DOCUMENT CHANGE REQUEST

DCR number 558

Title: Accessories for Connectors Microminiature 3401/029, 3401/077 and Connector Savers 3401/041

Number: 3401/032

Variant 10 - Screwlock Assembly for Connector Savers

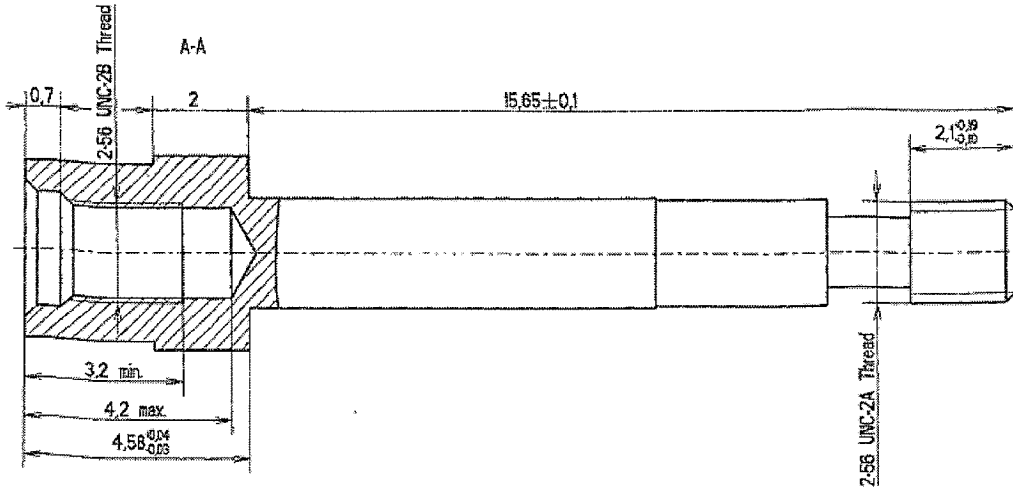
Page 10 : representation of the screwlock to be modified as shown in the attached document.

No word changing, only diameter of the screwlock added on the picture and 2 diameters very similar replaced by a single one.

Design modification and simplification
Current representation with 2 diameters very similar and no value specified is replaced by a single diameter of 2.13 mini.
Modification submitted to O. Perat and approved (see attached e-mail)
